# Permit Plans (8-2-22) STP Bone & Joint Clinic (Markups & Markup Summary).pdf Markup Summary

# NEW ADDITION DR. HONTAS MEDICAL OFFICE BUILDING

Commercial Plans  
RECEIVED  
8/2/2022  
DEPARTMENT OF  
ENGINEERING  
ENGINEERING  
REVIEW COPY

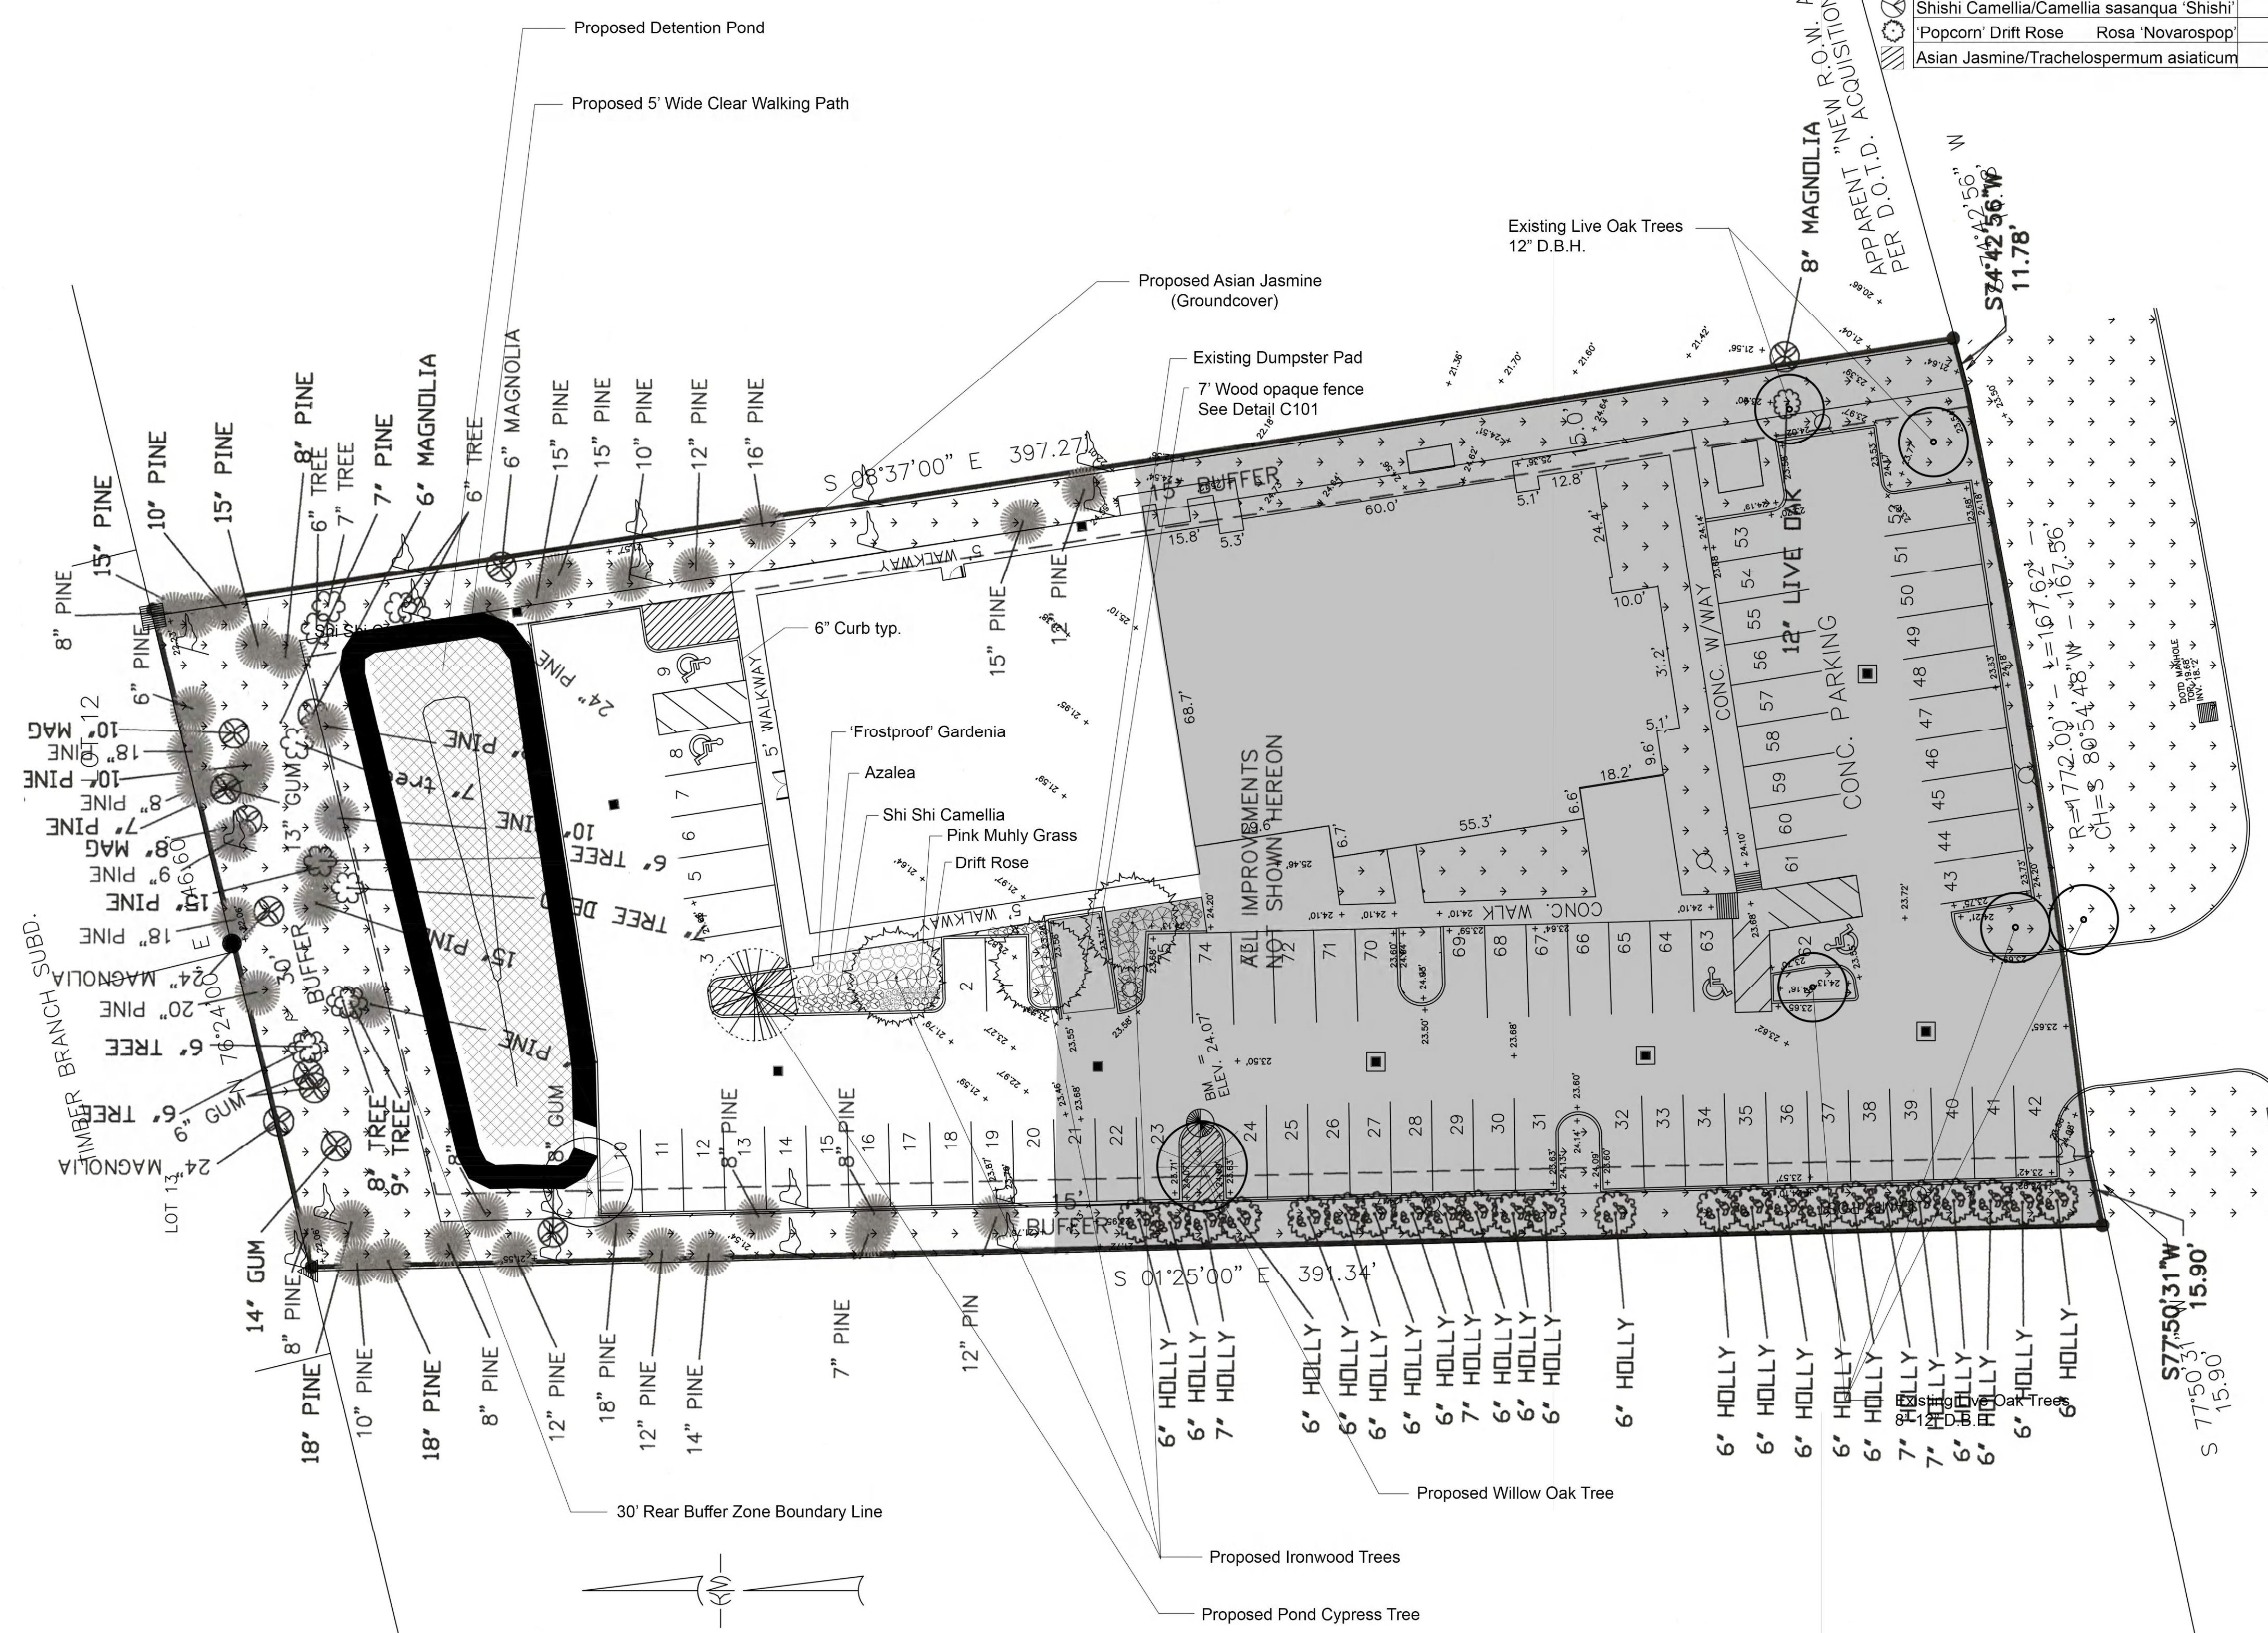
Add Note:

Buffers shall not be used as a laydown yard during construction. Any damage to existing trees in buffers will result in replacement plantings to meet code and revised landscape plan to match.

Buffers shall not be used as a laydown yard during construction. Any damage to existing trees in buffers will result in replacement plantings to meet code and revised landscape plan to match.

DRAWING NUMBER:  
**C104**

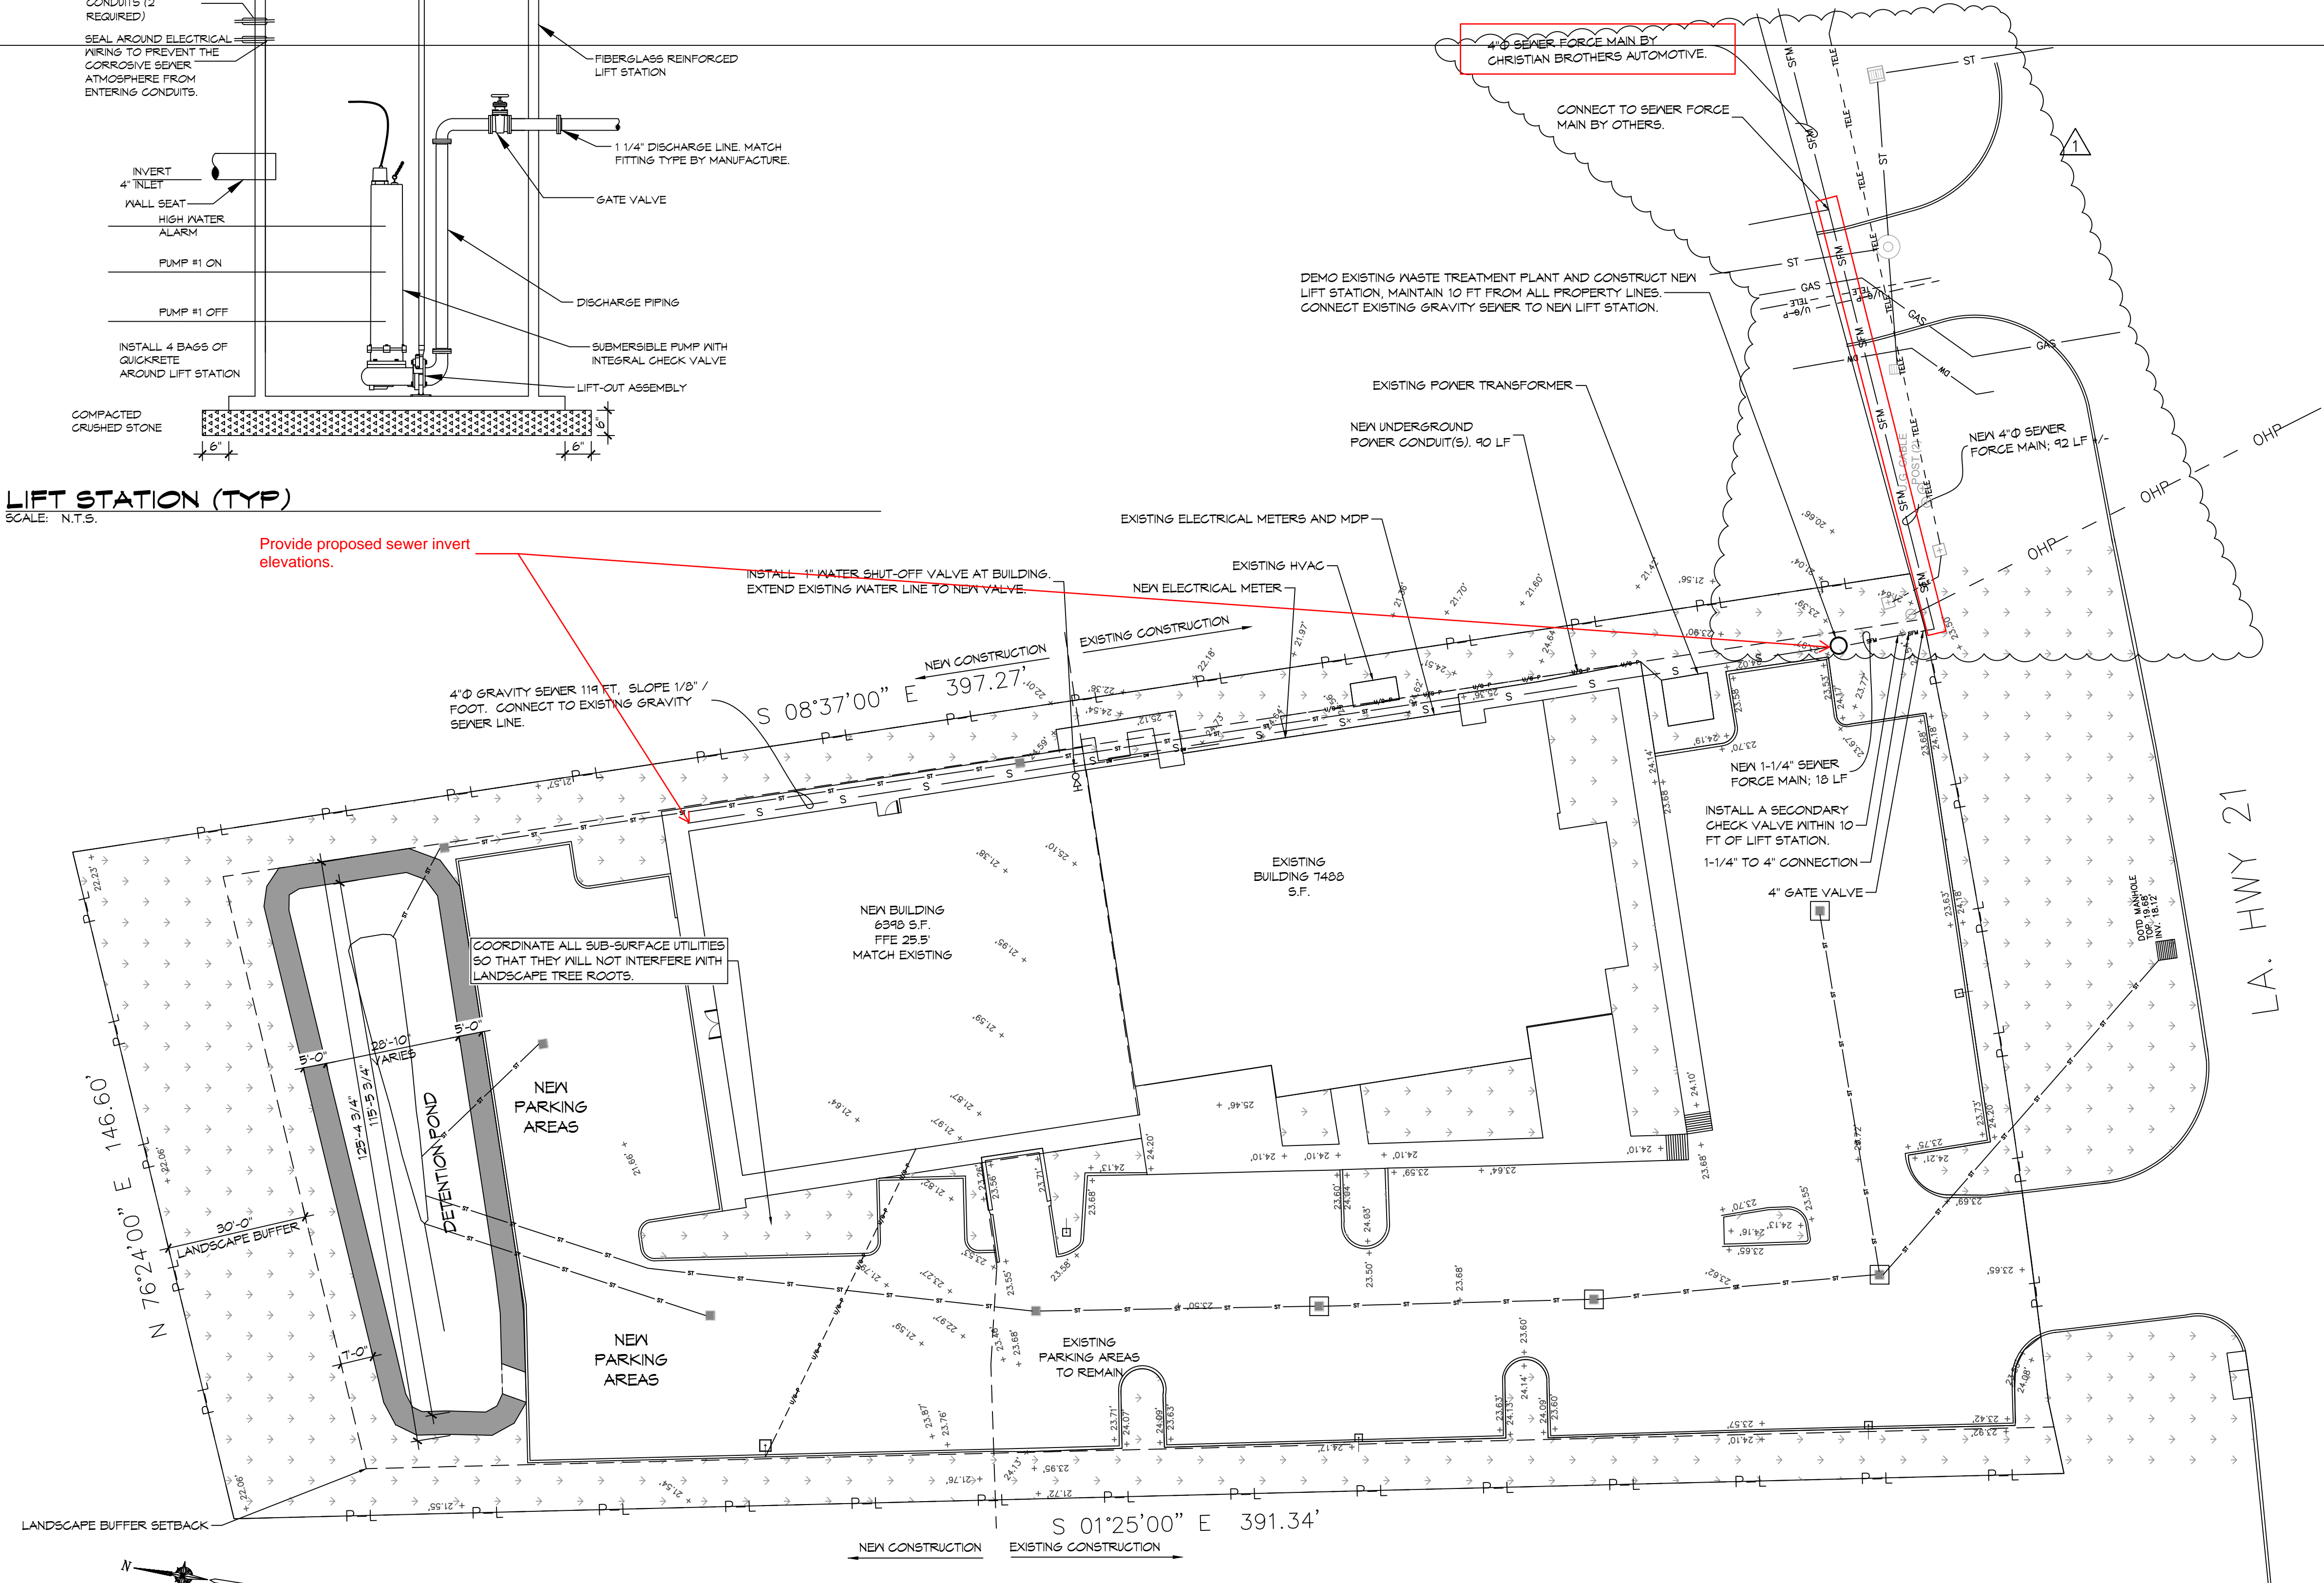
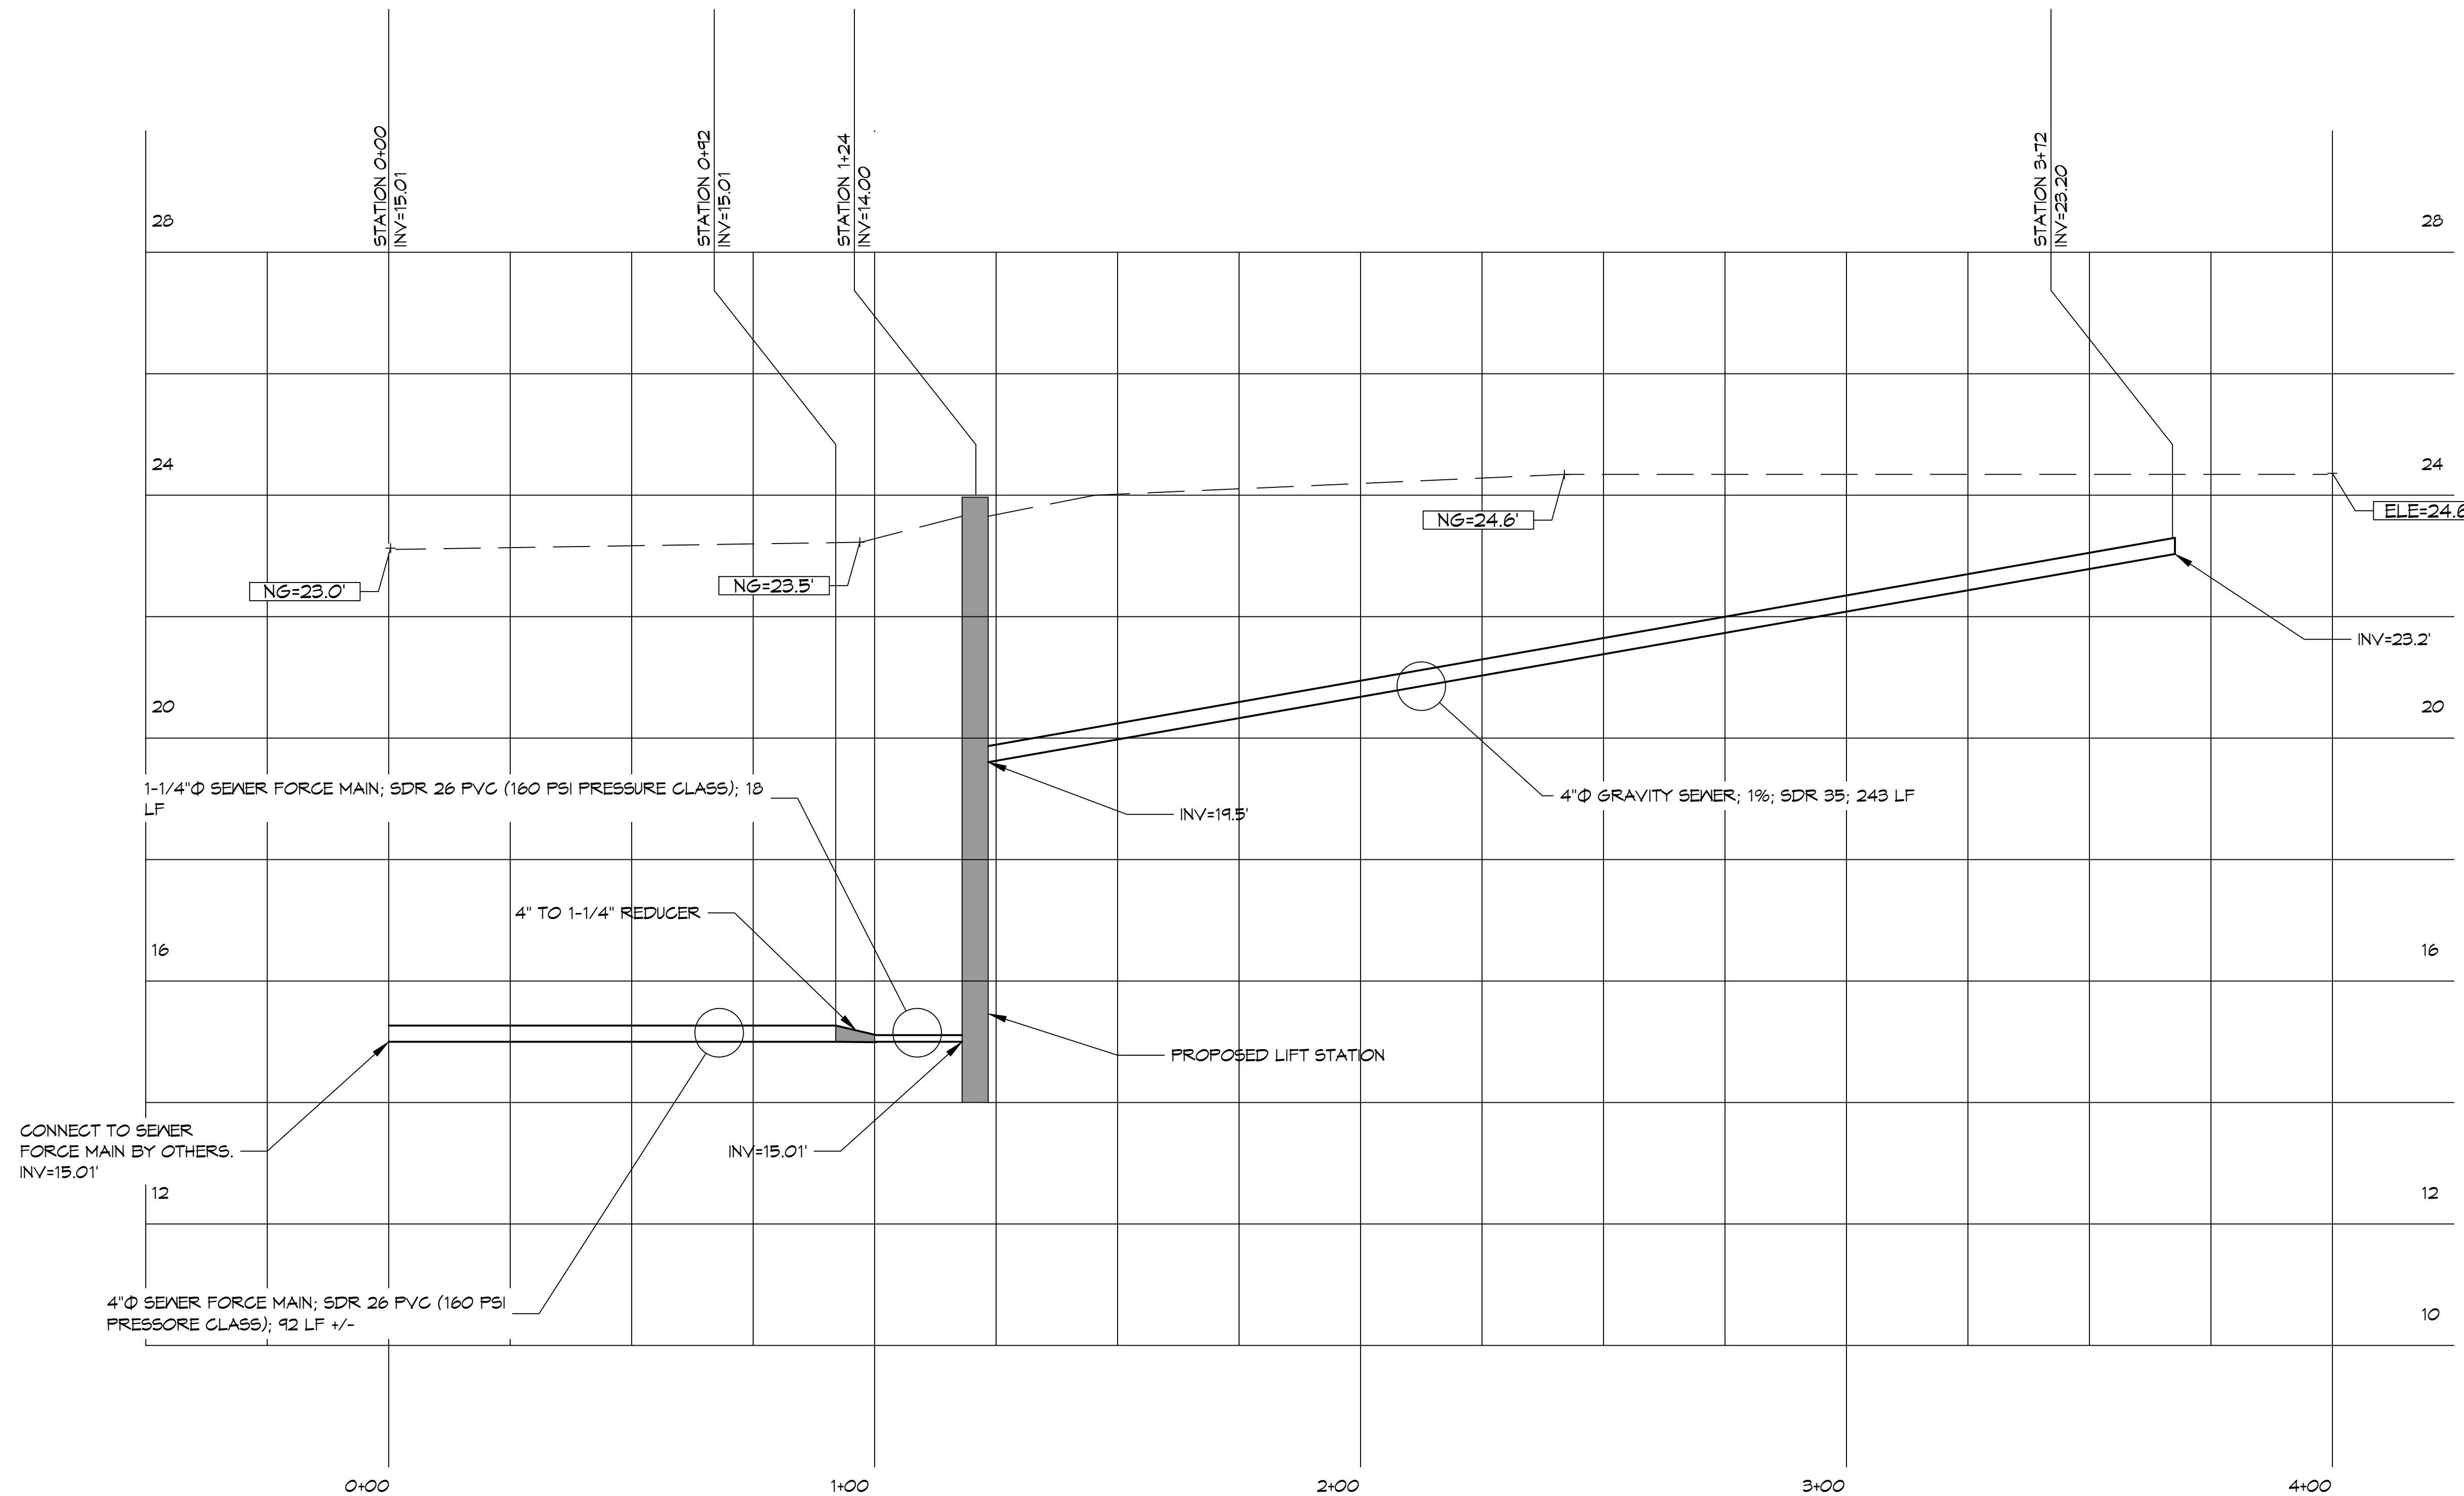
Provide proposed sewer invert elevations.

They are currently connected to TU for water service only. Tommie spoke to Andrew regarding the sewer service. He advised that a line extension would be needed for the sewer force main. The plans for the line extension would need to be approved by the Department of Utilities and LA Department of Health.

Unable to allow issuance until in receipt of plans and specifications (P&S) for sewerage line extension. Once we forward the P&S along with our letter of no objection to Louisiana Dept., of Health (LDH), we can sign off on this permit and hold the occupancy for LDH approval, as built(s) from the project's professional engineer and verification of connection to Tammany Utilities Company.

Provide as-built plans and letter of acceptance from utility provider for 4" diameter sewer force main.

Provide proposed sewer invert elevations.
